## ALERT SERVICE BULLETIN

**505-20-15**

**MODEL AFFECTED:** 505

**SUBJECT:** ENGINE OIL TANK P/N SLS-065-100-037,  
INSPECTION OF

**FIGURE 1 – Oil tank**

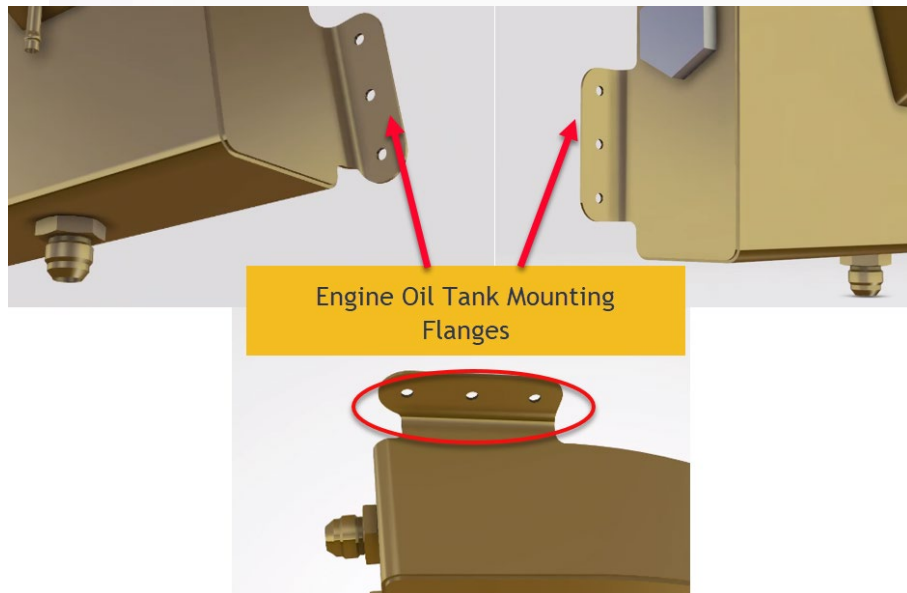
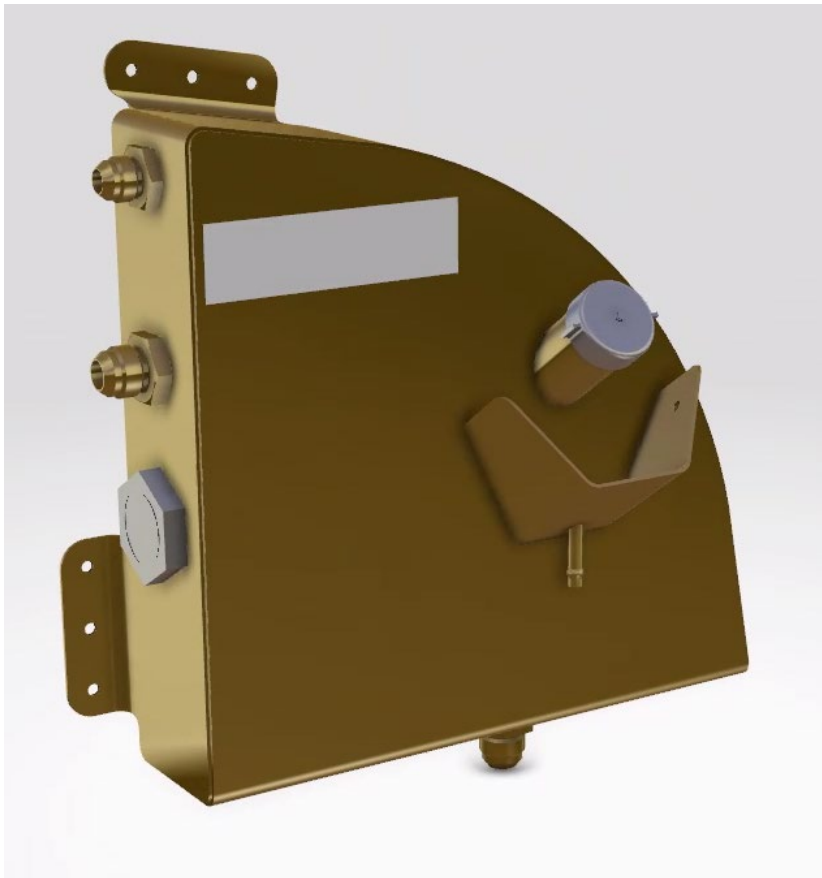
1. Prepare the helicopter for maintenance.
2. Remove transmission fairings 432BR and 432AL to gain access to the engine oil tank (Figure 1), (DMC-505-A-53-40-01-00A-520A-A and DMC-505-A-53-40-02-00A-520A-A).

2. Remove transmission fairings 432BR and 432AL to gain access to the engine oil tank (Figure 1), (DMC-505-A-53-40-01-00A-520A-A and DMC-505-A-53-40-02-00A-520A-A).

**FIGURE 2 – Area to be inspected**

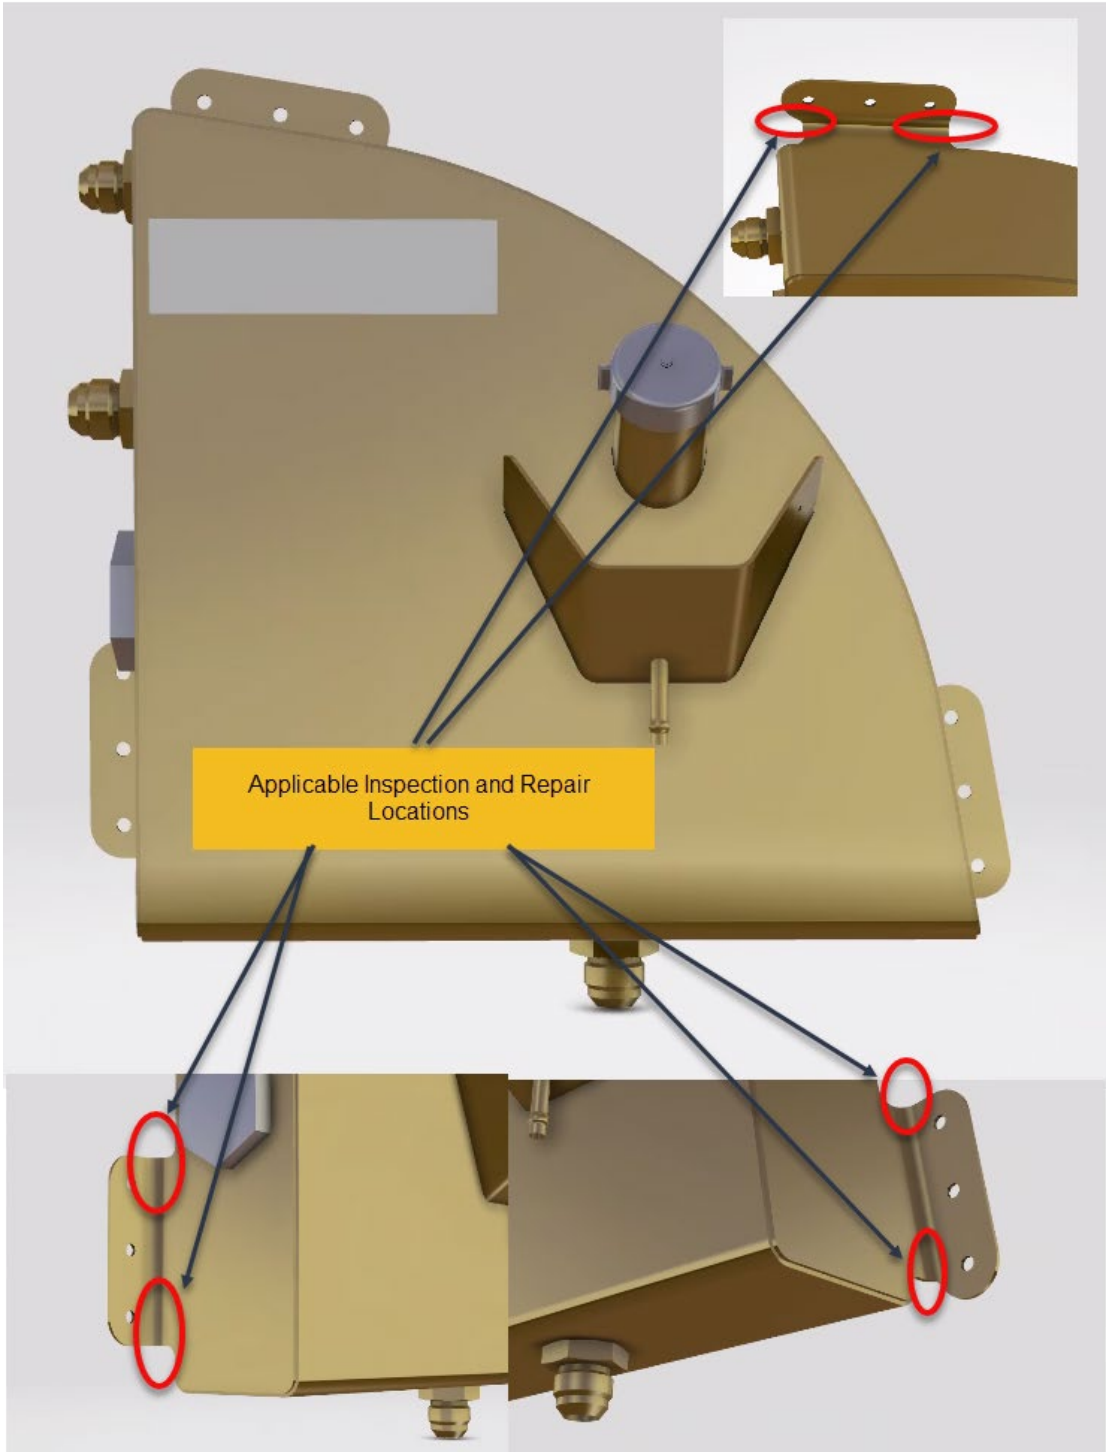
3. Inspect without removing the tank from the firewall, as follows:
  - a. Clean the surface of the three mounting attachment flanges in the affected area (Figure 2) with acetone (C-316). Cracks will typically originate at the edge of the mounting flange.

- b. Visually inspect the three mounting attachment flanges from the forward side of the oil tank for cracks in the radius with a strong light source and a 10x power magnification (Figure 2).

A single crack in mounting attachment flanges longer than 0.050" (1.27 mm) shall be trimmed but not to exceed the repair dimensions in (Figure 3). Repair trimming can be applied to any of the six indicated locations from Figure 2 as required with the maximum of one repair per mounting attachment flange.

3. Remove oil tank assembly (DMC-505-A-79-10-01-00A-520A-A).
4. Perform FPI to forward and aft side including the weld bead of all attachment mounting flanges to confirm the absence of crack(s) in the area to be inspected shown in Figure 2 using instructions and materials detailed in Chapter 6 of Standards Practices manual (BHT-SPM-ALL)

**FIGURE 3 – Maximum repair cut dimensions**

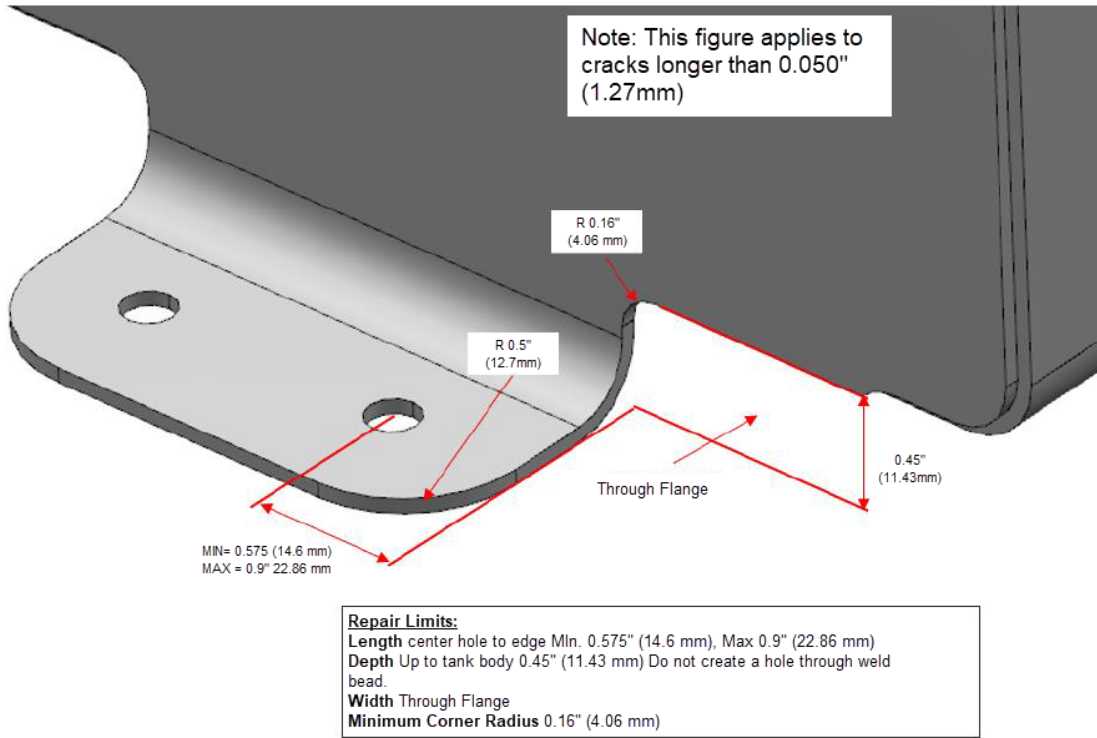
- b. Manually trim the mounting attachment flange to completely remove the crack. Remove approximately 0.010 inch (0.254mm) of material past the end of the crack but not beyond to dimensions shown in Figure 3. Deburr sharp edges, remove debris and loose material.

5. If the flange repair required enough material removal to eliminate one of the attachment holes, use the previously removed attachment screw with an additional washer to compensate for the removed flange section. This will prevent the screw from bottoming on the shank at installation.
